Date: October 12, 2022
To: City Council
From: Ellen Hardgrove, City Planning Consultant
XC: Sandy Riffle, Interim City Clerk
Brett Sollazzo, Administrative Assistant
Drew Smith, City Attorney
Allen Lane, City Engineering Consultant
Re: ECD Waivers Related to Proposed Car Wash at 4800 South Orange Avenue.

This agenda item is a request for waivers to ECD standards for a proposed car wash at 4800 South Orange Avenue, the current location of the Coq Au Vin Restaurant as shown in Exhibit 1.

Exhibit 3 – Proposed Car Wash Layout

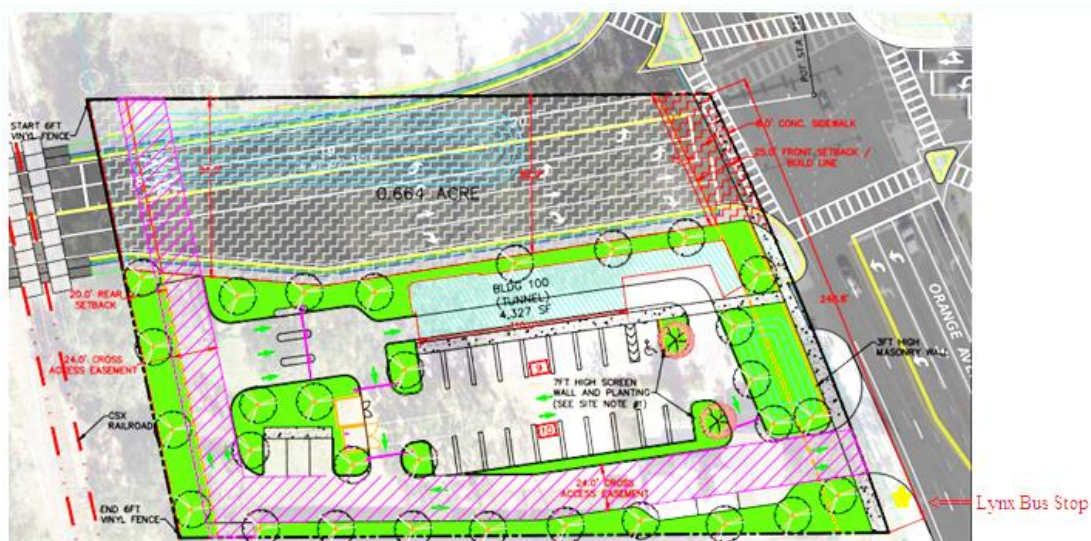
The primary waiver requested is to allow the building to only face 11.25% of the Orange Avenue frontage (28 feet building frontage with 248.8 feet lot width) instead of the required 70% (Code Section 134-468(f)). According to the applicant, the premise for the waiver is to help achieve the City's goal to provide a solution to the traffic issues created by Holden/Orange/Gatlin Avenues offset intersections by limiting the development to the southern 2/3's of the property to preserve the north 1/3 for a potential Holden Avenue realignment.

With use of the waiver, the applicant would build the car wash tunnel/building perpendicular to Orange Avenue and use the north 1/3 of the property only for stormwater management. If Holden Avenue is realigned, the idea is to accommodate the stormwater from the car wash into the road's stormwater management system. Exhibit 3 shows the proposed site layout with the conceptual alignment for the Holden Avenue realignment as shown in Orange County's Intersection Analysis Study (March 2022) superimposed over the car wash site layout.

A waiver would still be needed if that portion of the property were already acquired for the realigned road; the proposed building frontage would account for only 16% of the property frontage, still significantly substandard for the ECD requirement.

The Planning and Zoning Board (P&Z) supported this waiver with conditions after discussion relative to a car wash potentially being at a major intersection in the city. However since the P&Z meeting, Orange County BCC eliminated the potential for Holden Avenue to be realigned. Thus the premise for the waiver is negated.

As such, staff recommends denial of the request; a proposed development with only 11.25% of the frontage occupied by a building is contrary to the intended land use pattern and design standards of the ECD. The principal goal of the ECD is to create a land use pattern that encourages interest in walking, transitioning from an auto oriented land use pattern.

Exhibit 4 – Proposed Vacuum Screen Wall Locations

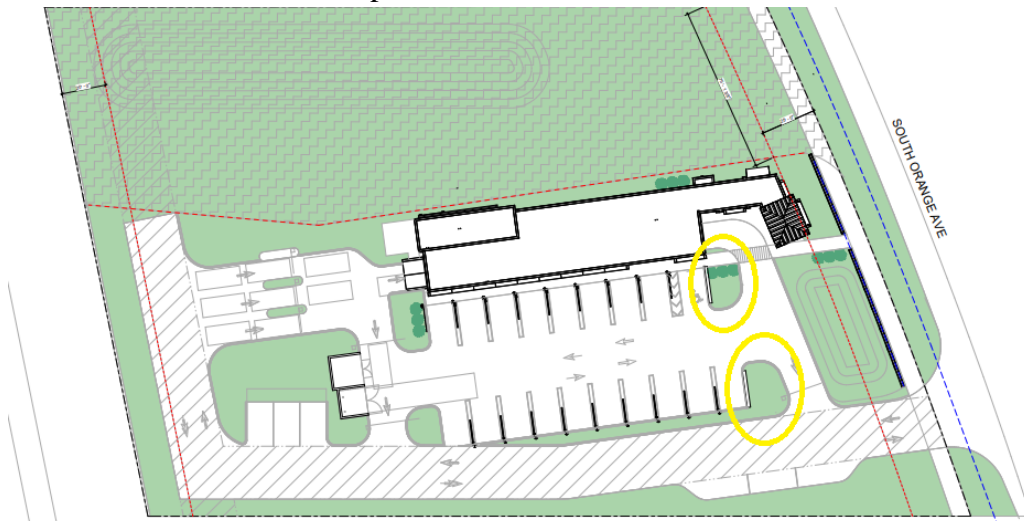
The applicant is also requesting a waiver to allow the vacuum stations to be screened from Orange Avenue with an alternate design than that required by Code Section 134-472(a)(4). The vacuum screen walls are circled in Exhibits 4 and 5.

ECD design standards require those walls to be consistent with ECD front elevation standards such as, but limited to, window transparency and avoidance of blank walls. The applicant justifies the need for this waiver as a consequence to turning the building in order to preserve the northern 1/3 of the property for the Holden Avenue realignment.

P&Z recommended approval of this requested waiver with conditions based on the justification to turn the building perpendicular to Orange Avenue. Again, since Orange County BCC eliminated the potential for Holden Avenue to be realigned, the site plan will need to be completely recreated. A new site layout would likely result in the lack of need for this waiver. Thus, at this time, staff recommends denial of the request.
